WEPA Response to the  
Transport for NSW  
Beaches Link and Gore Hill Freeway Connection  
Environmental Impact Statement

28 February 2021

Figure E-2 Key metrics for the Eastern Harbour City's transport network

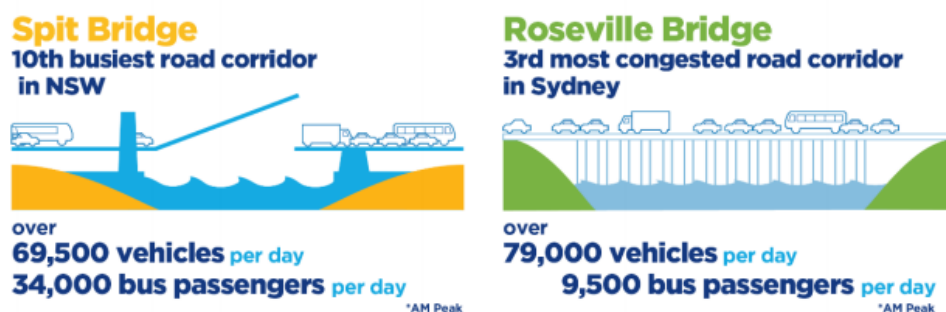
Finally, it is noted that the proponent states the project will only provide meagre benefits for the Spit Road/Military Road corridor in any event with a 10% reduction from current travel volumes by 2037.
